SUNDRY NOTICES AND REPORTS ON WELLS

2. NAME OF OPERATOR
Hixon Development Company

Carson Unit

324-19

Hixon Development Company Pressure Control Equipment

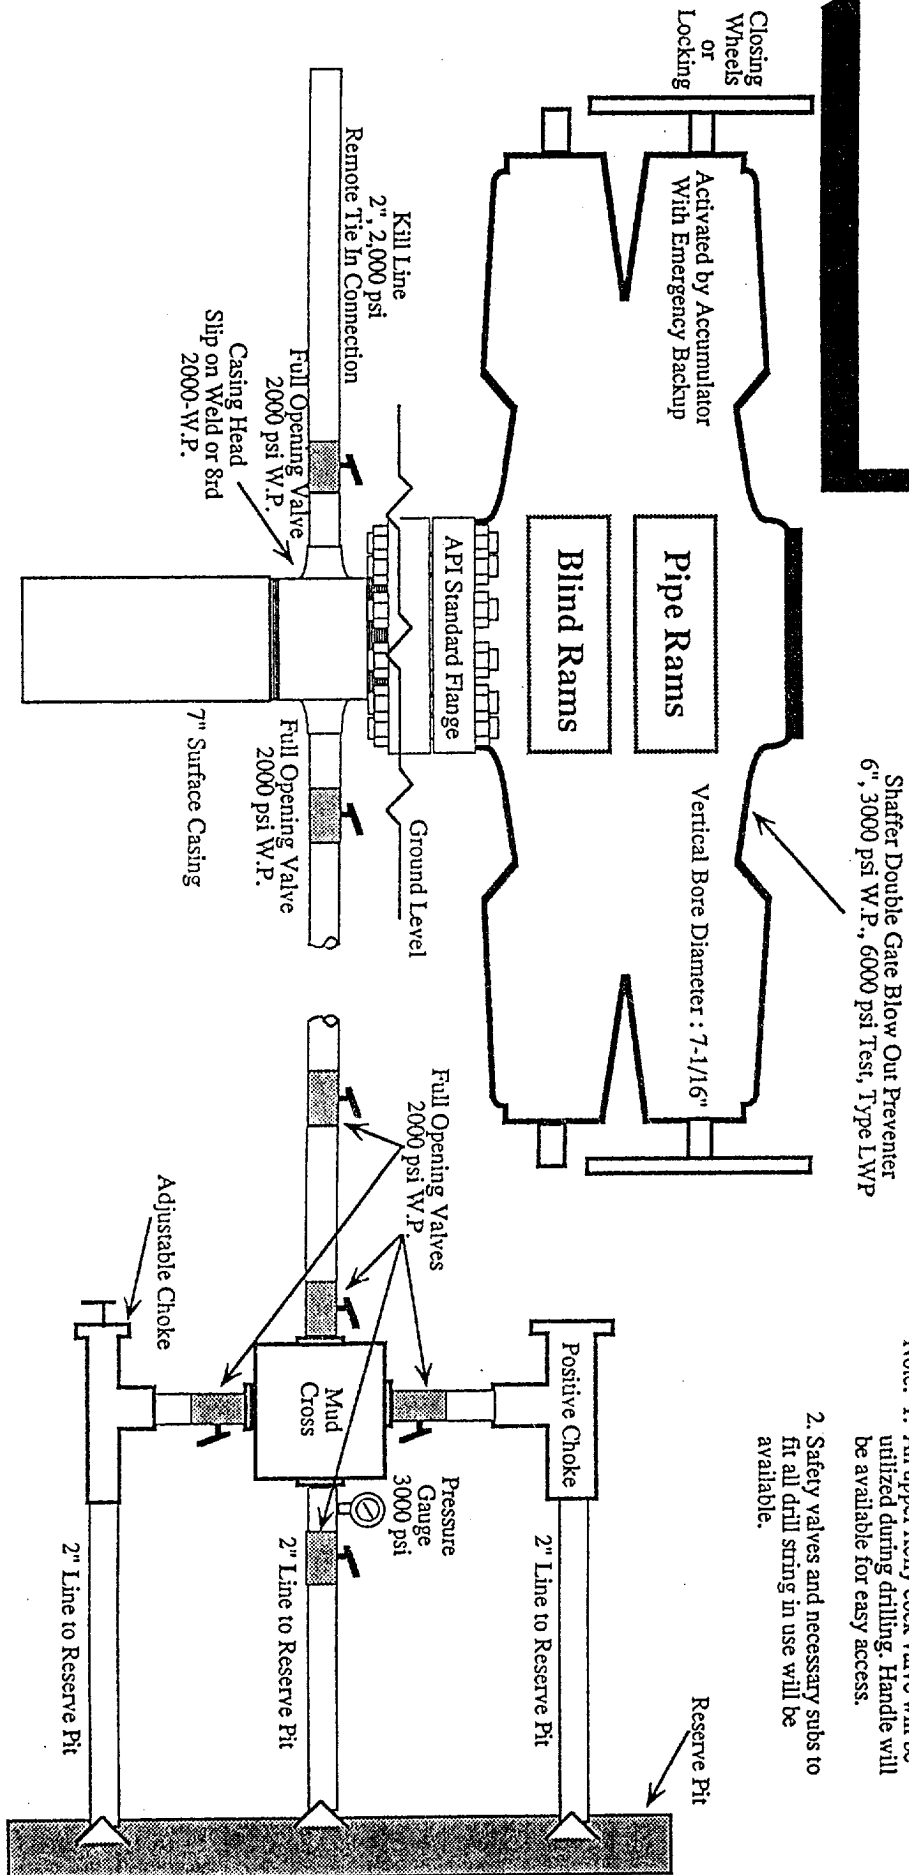
Attached are an amended Pressure Control Equipment Schematic
and Drilling Rig Location Plat.

- Note: 1. An upper Kelly cock valve will be utilized during drilling. Handle will be available for easy access.
2. Safety valves and necessary subs to fit all drill string in use will be available.
